# WMI INDUSTRIES, LTD.

RE: Window cutout or Camera on GRAVITRON door.

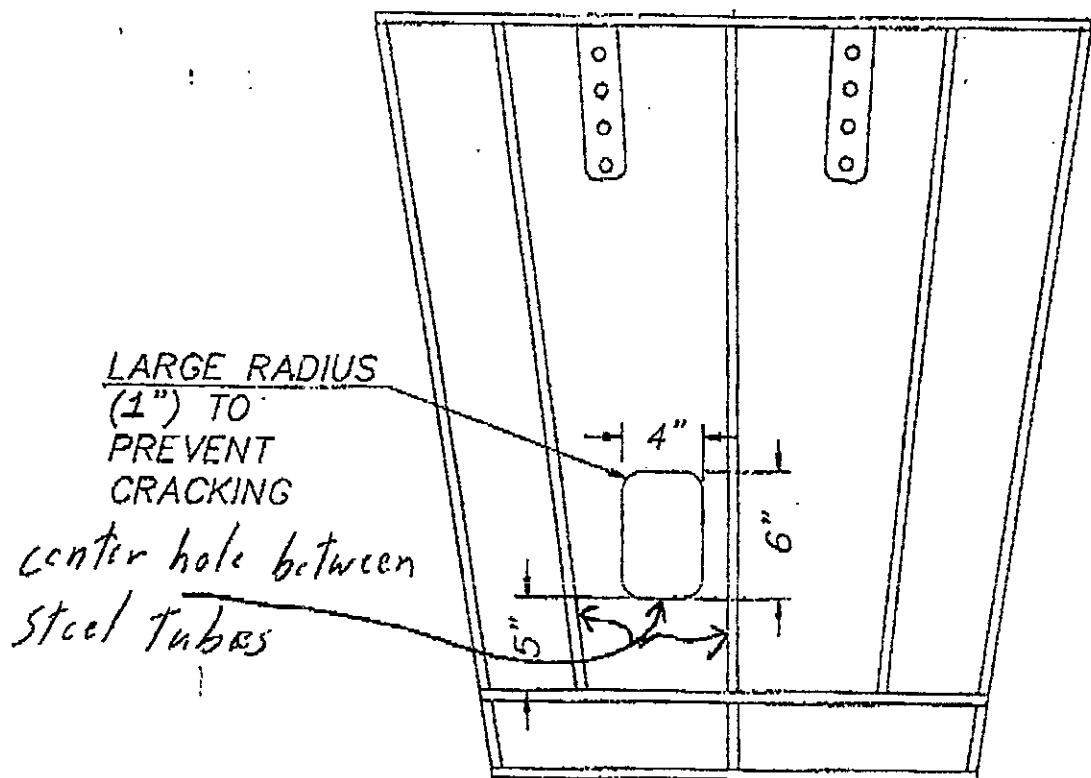
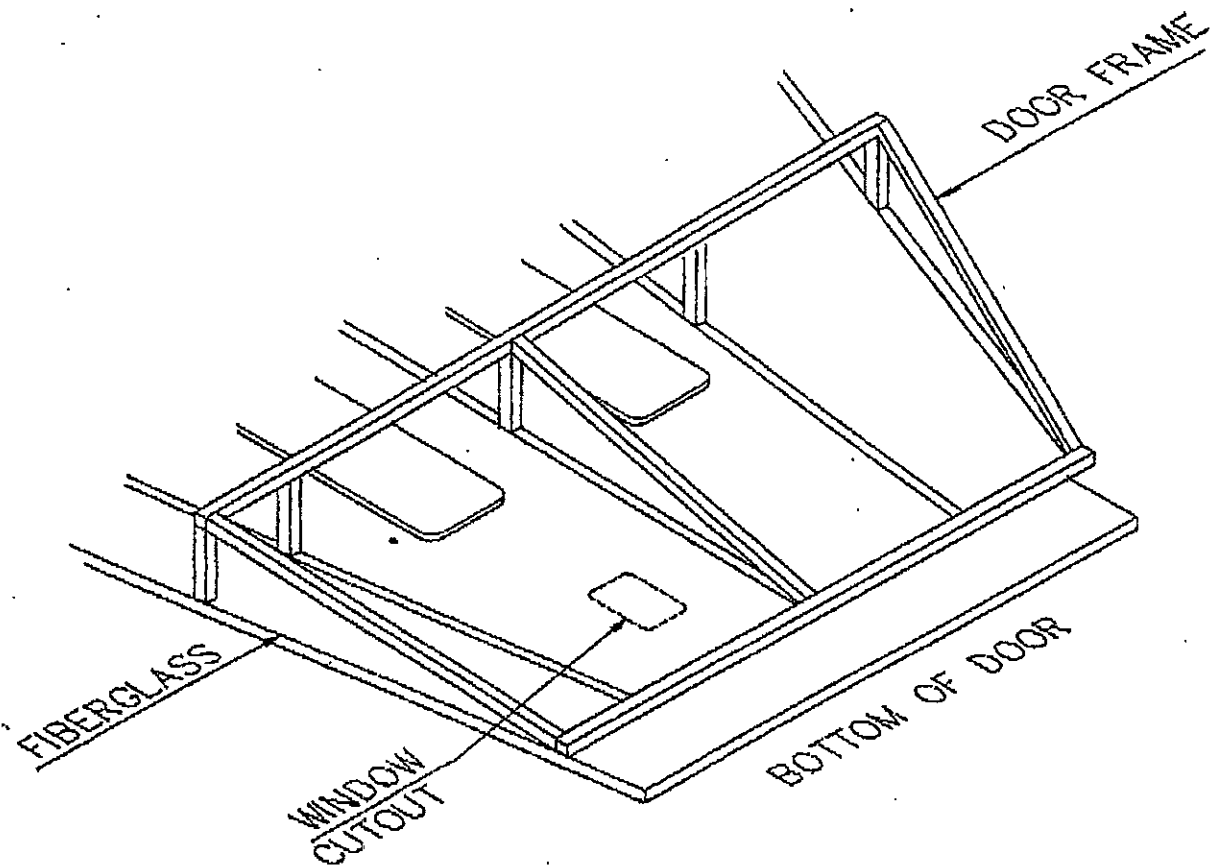
I just received a call from one of your inspectors about the cutout window in the GRAVITRON door. The ride specifically mentioned is owned by FARROW AMUSEMENTS. It is mandatory for either the camera to be installed and operating or the window cut in the door.

Enclosed is a copy of the cut out and the recommended location for the hole.

THIS DRAWING IS A TEMPLATE OF THE CUT-OUT AREA FOR THE PANEL WINDOW. CUT-OUT AROUND THE EDGE, AND TRACE AROUND THE OUTSIDE WITH A HEAVY BLACK MARKER TO MARK THE AREA TO BE REMOVED ON THE PANEL. THE WINDOW CAN BE MADE FROM A PIECE OF CLEAR LEXAN MEASURING 8 x 6 AND SHOULD BE ATTACHED ON THE INSIDE OF THE PANEL BY MEANS OF BOLTS, SCREWS, OR POP-RIVOTS (FROM THE OUTSIDE - IN).

It is acceptable for FARROW AMUSEMENTS to operate their GRAVITRON as long as ALL operators are instructed to not open the door more than 5" while the ride is moving. This will allow the operator to see the location of the stairs without creating a hazard for the passengers.

The window or camera system must be installed by January 29, 1993.
